Angel Road/Waterloo Road - change of priority at junction

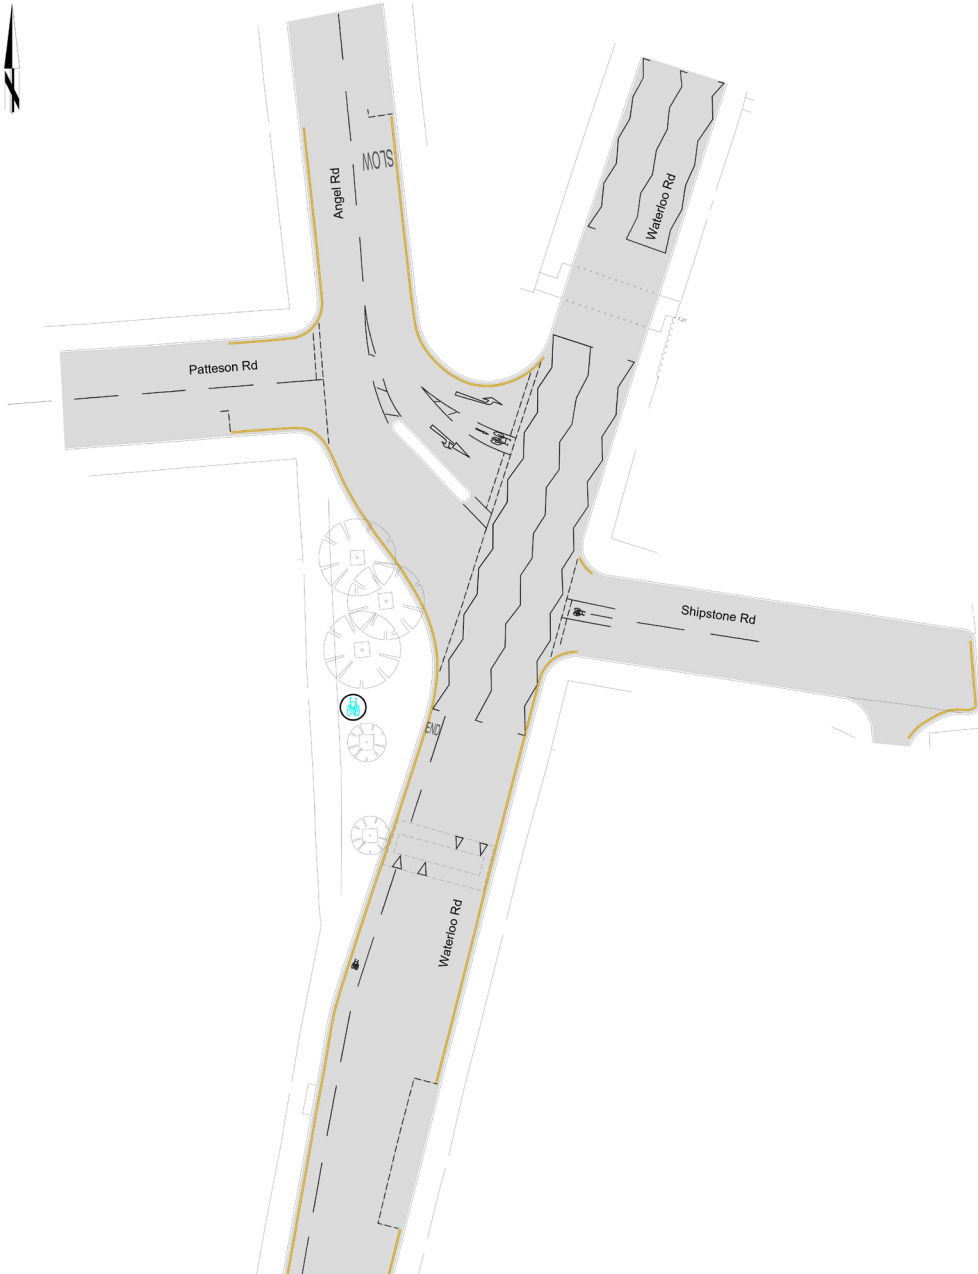
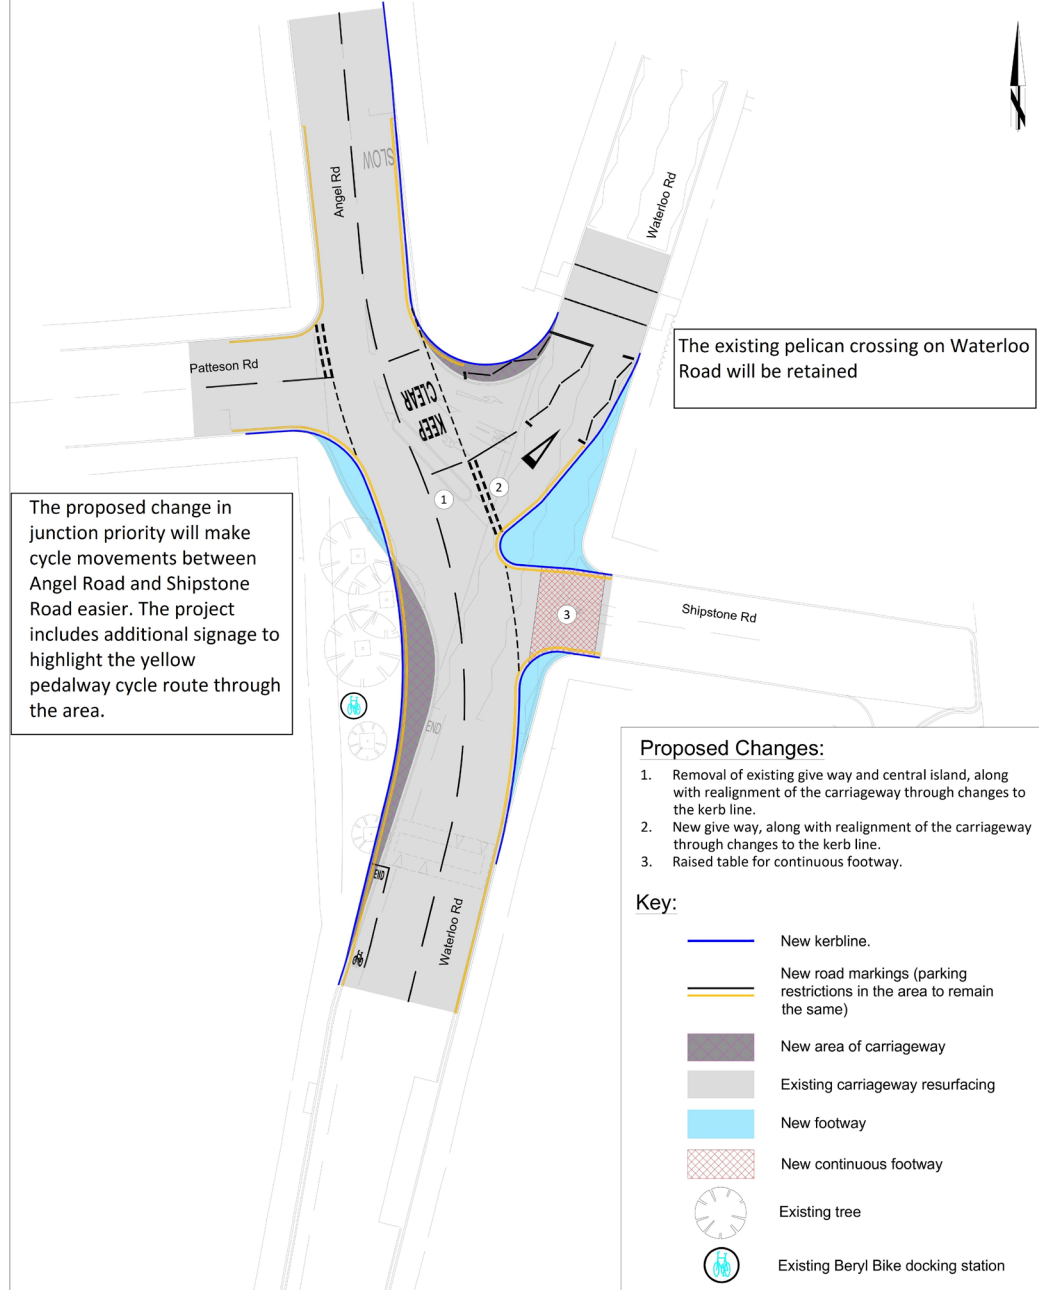
- Proposed Changes:**
1. Removal of existing give way and central island, along with realignment of the carriageway through changes to the kerb line.
 2. New give way, along with realignment of the carriageway through changes to the kerb line.
 3. Raised table for continuous footway.
